ALDI ADC

Modification 1

June 2026

Prepared for: ALDI Foods Pty Ltd

Figure 2 Mezzanine Level

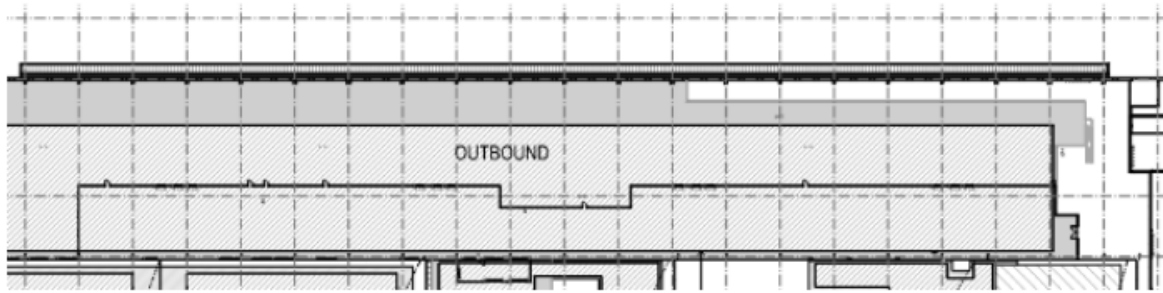
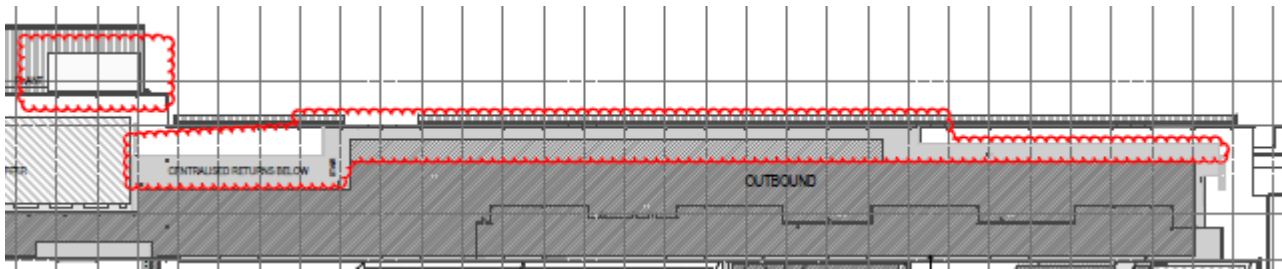
The GFA addition of 2,500 sqm is illustrated in the revised architectural drawings, refer Drawing DA-110 Mezzanine – Level 1, Rev 1, dated 29 May 2026 (**Appendix A**) lodged with DPHI under this modification. The revised architectural drawings illustrate the internal minor updates at the mezzanine levels as a result of detailed design, comprising both additions and subtractions that result in a net GFA addition of 2,500 sqm. These changes are shown in Figure 2 below.

Figure 3 Energy Centre 1 (Changes in red cloud)

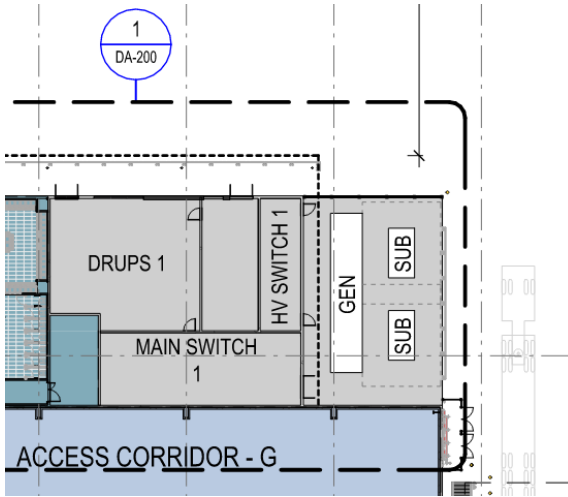
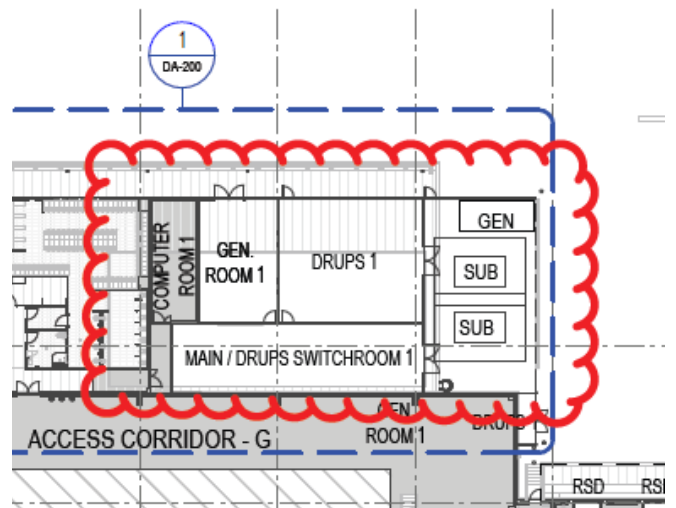
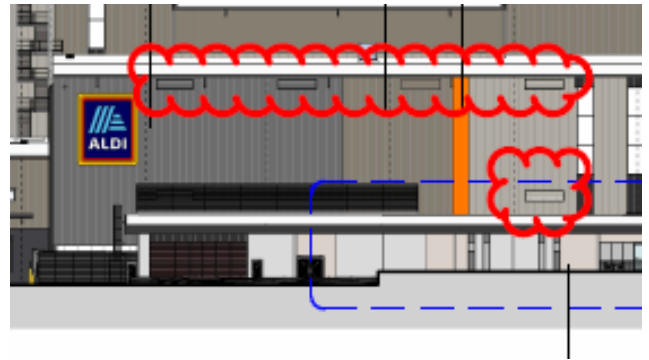
Energy Centre 1 is proposed to be extended and reconfigured in line with the developed design, with associated amendments and relocation of screening on the elevation. Given this extension area is defined as 'plant' it does not constitute GFA.

The Energy Centre extension is longitudinal along the building facade and does not encroach upon any vehicle manoeuvring areas, loading docks, car parking, or pedestrian pathways. The extension has no bearing on the approved traffic and vehicle movement arrangements for the site and does not give rise to any additional traffic or access impacts.

Figure 4 Energy Centre 2 (Changes in red cloud)

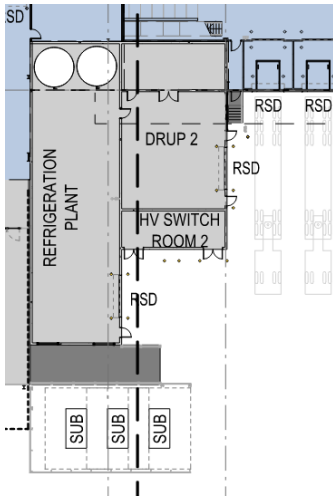
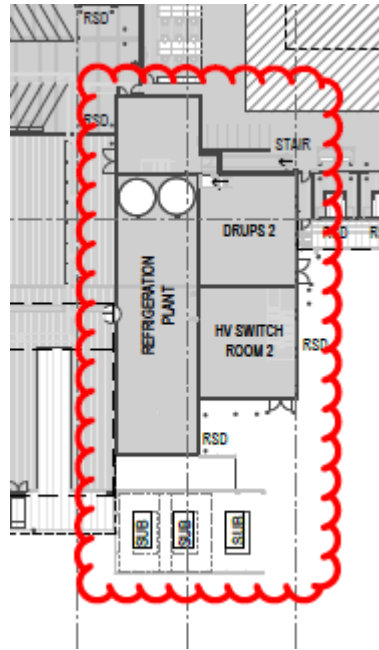
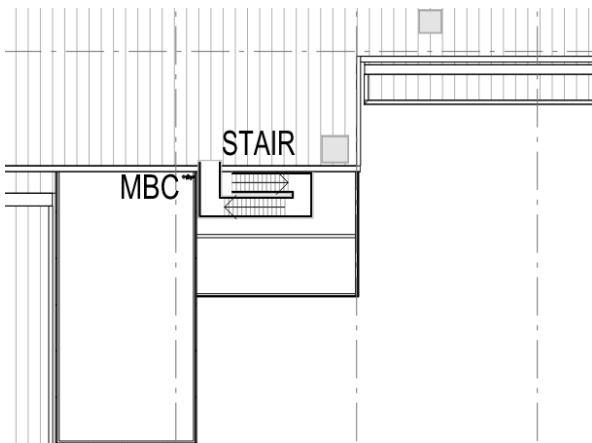
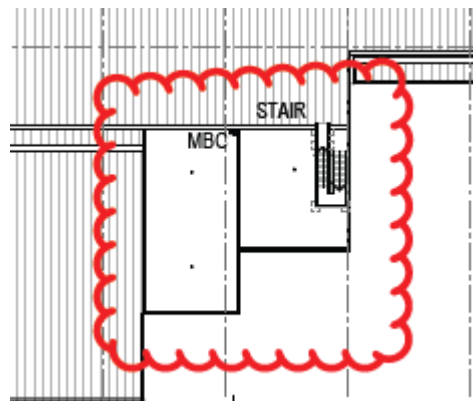
Energy Centre 2 is proposed to be extended and reconfigured in line with the developed design. This has led to roof staircases and plant being amended on the roof plan and the roof staircase elevation. Given this extension area is defined as 'plant' it does not constitute GFA.

The Energy Centre extension is longitudinal along the building facade and does not encroach upon any vehicle manoeuvring areas, loading docks, car parking, or pedestrian pathways. The extension has no bearing on the approved traffic and vehicle movement arrangements for the site and does not give rise to any additional traffic or access impacts.

Figure 5 Energy Centre 3

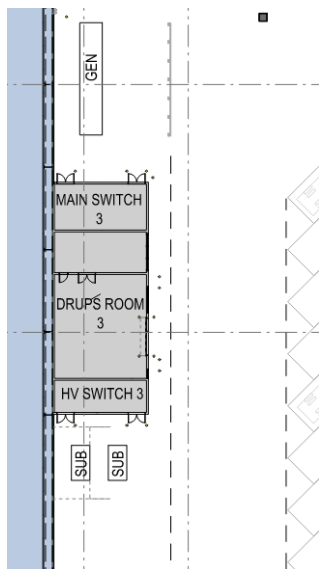
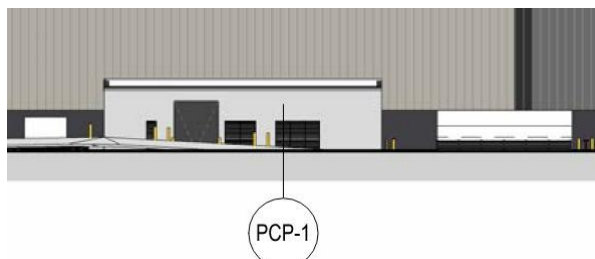
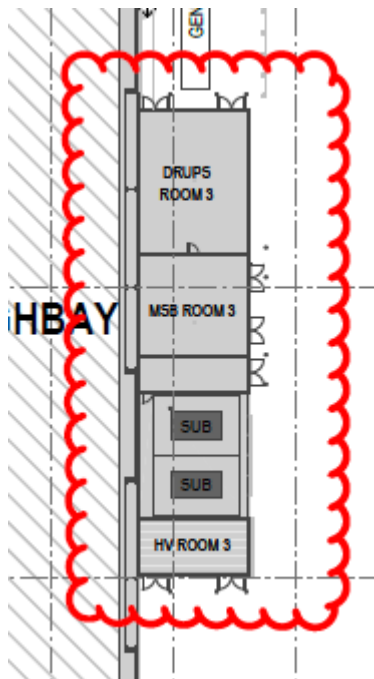
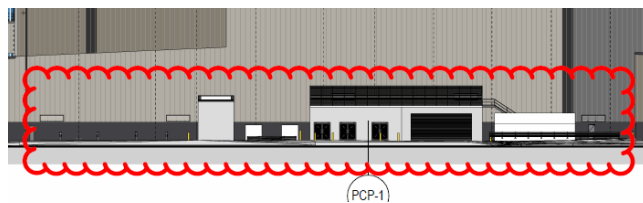
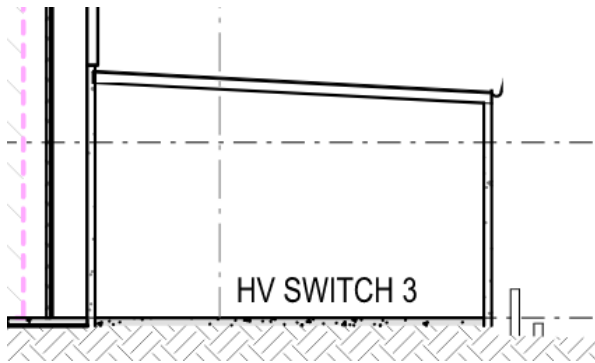
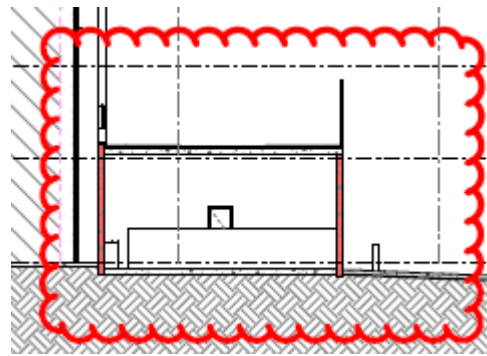
Energy Centre 3 has been extended and reconfigured in line with the developed design, with a new roof screen added to house covered solar inverters and a staircase for roof access. Given this extension area is defined as 'plant' it does not constitute GFA.

The Energy Centre extension is longitudinal along the building facade and does not encroach upon any vehicle manoeuvring areas, loading docks, car parking, or pedestrian pathways. The extension has no bearing on the approved traffic and vehicle movement arrangements for the site and does not give rise to any additional traffic or access impacts.
